SERVICE BULLETIN

SERVICE BULLETIN NO: 24-010

ELECTRICAL POWER - DC GENERATION REPLACEMENT OF GENERATOR 2

Replacement of the Generator 2 (P/N 524.32.12.147) with a new generator (P/N 524.32.12.158).

Voltage Spike Suppression Filter - Schematic - Pre-change of Location (Post SB 24-010)
Figure 8 (Sheet 1 of 2)

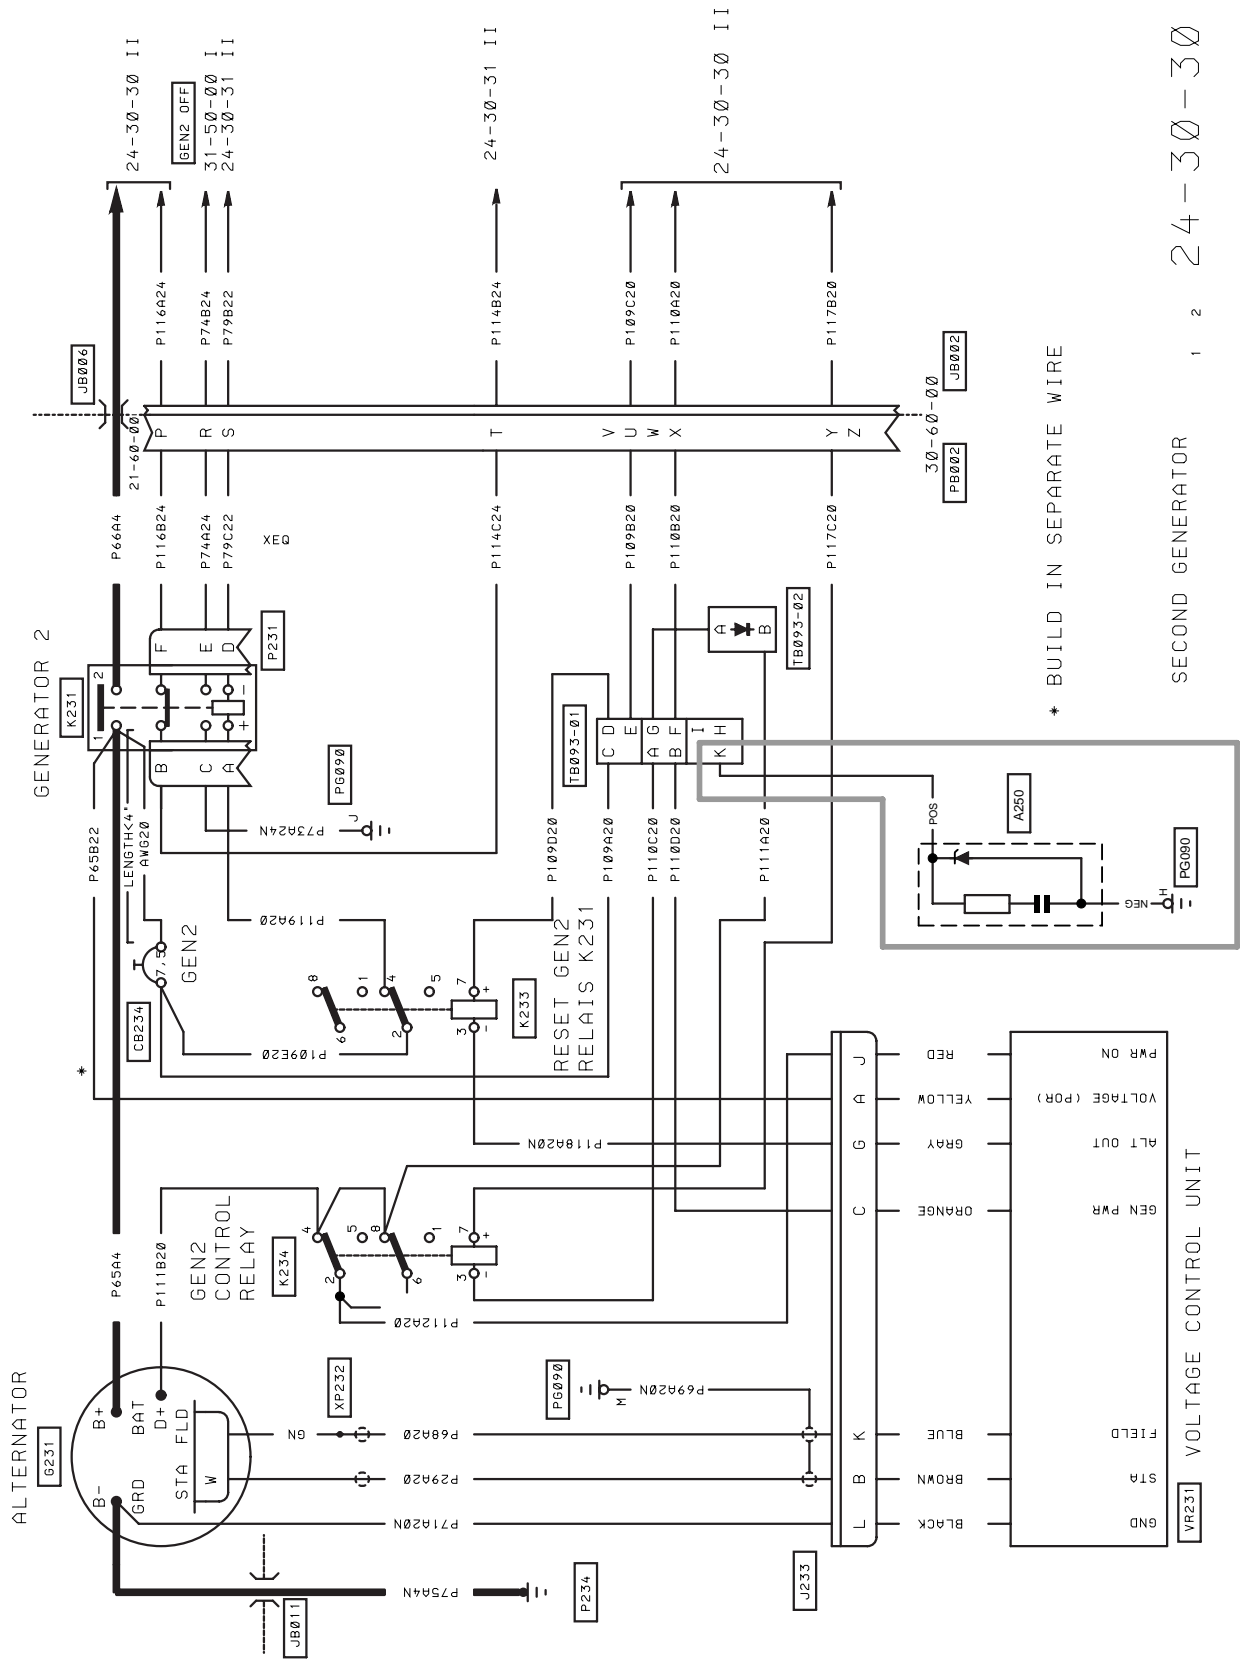
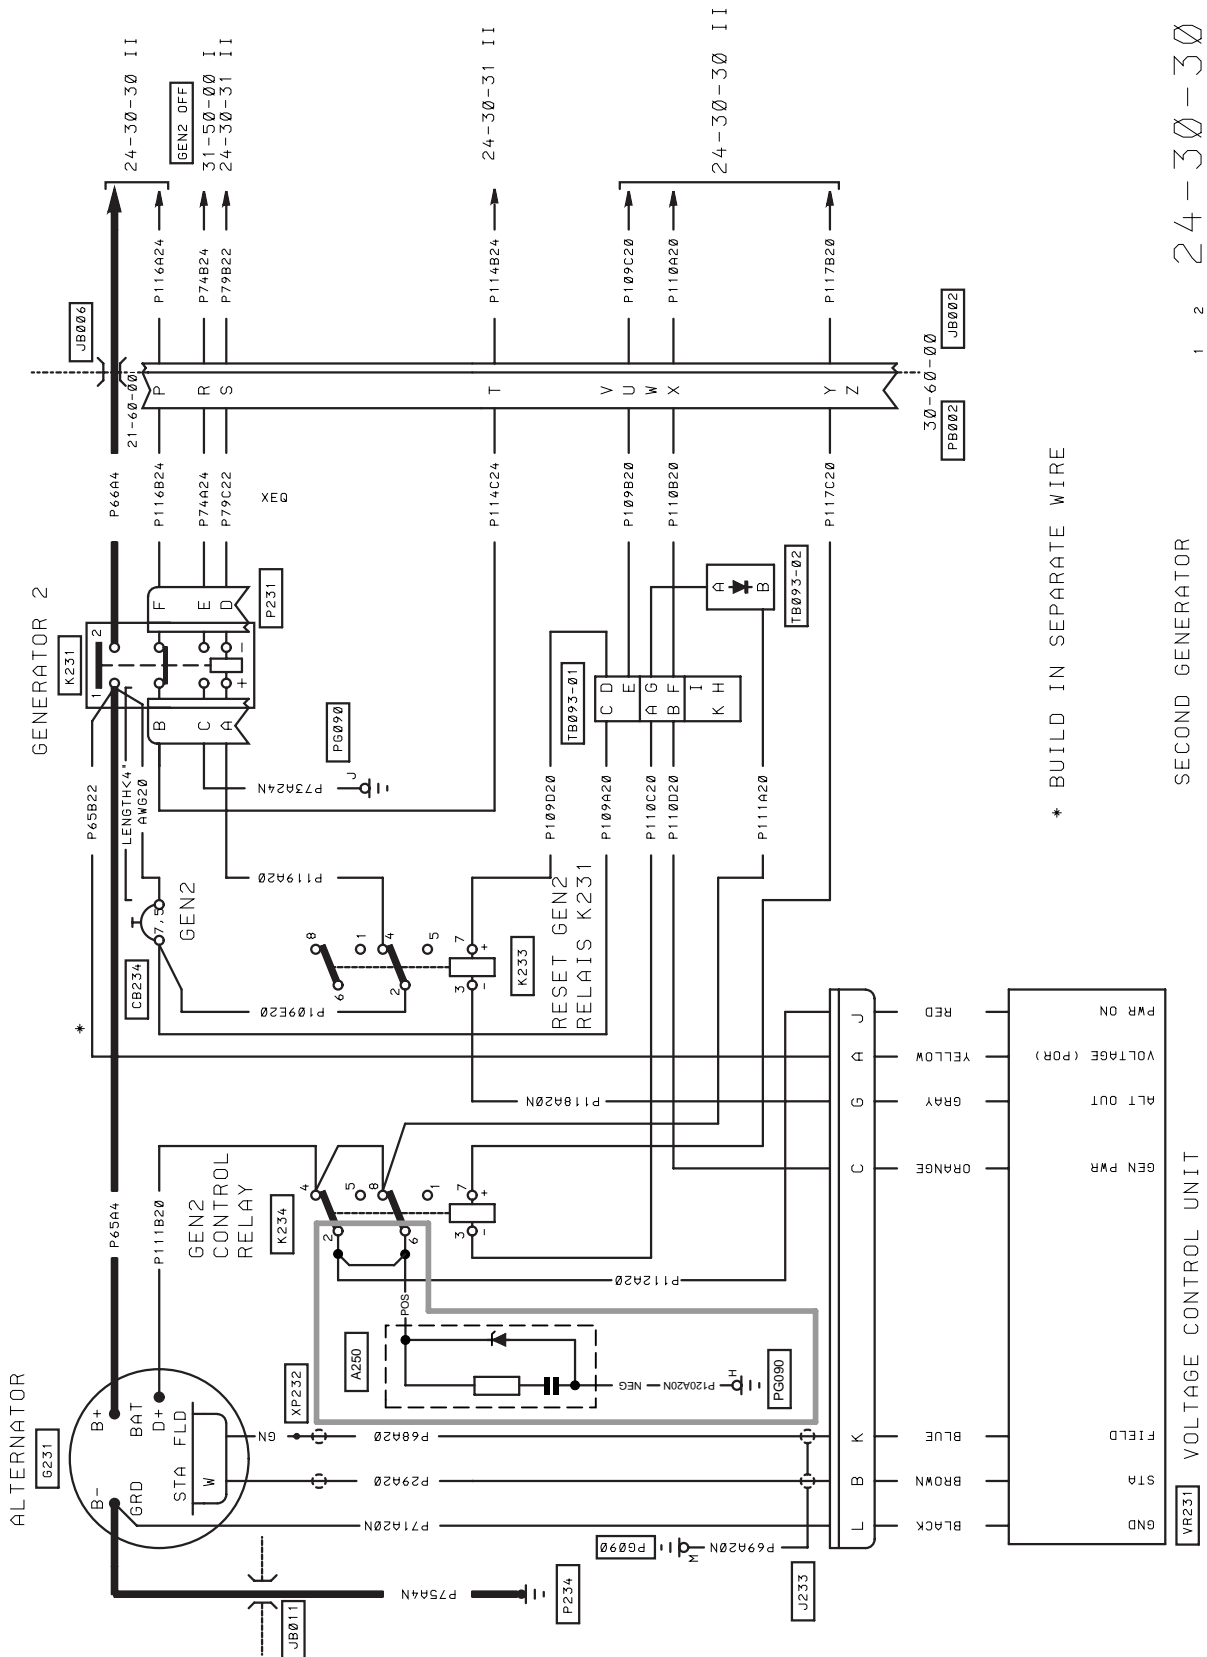
I. Voltage-spike Suppression Filter - Change Location (Ref. Fig 8)

- (1) Disconnect the Positive wire of the voltage -spike suppression filter (filter) (A250) from the terminal block (TB093-01/K). The filter is installed adjacent to the terminal block (TB093).
- (2) Remove and discard the end contact from the Positive wire of the filter (A250).

- (3) Disconnect the negative wire of the filter (A250) from the ground terminal (PG090/H).
- (4) Remove and discard the end contact from the Negative wire of the filter (A250).
- (5) Connect the link and Positive wires.

- link wires (AWG20) connected to the relay (K234, Pins 2 and 6)
- Positive wire of the filter (A250)

(b) Use the applicable crimp tool and install the in-line splice (blue) to connect the link and Positive wires (AWS20).

- The end of the Negative wire of the filter (A250)
- One end of the wire (P120A120N)

(b) Use the applicable crimp tool and install the in-line splice (red) to connect the wire (P120A120N) and the Negative wire of the filter (A250).

(7) Connect the wire (P120A120N) to (PG090/H).
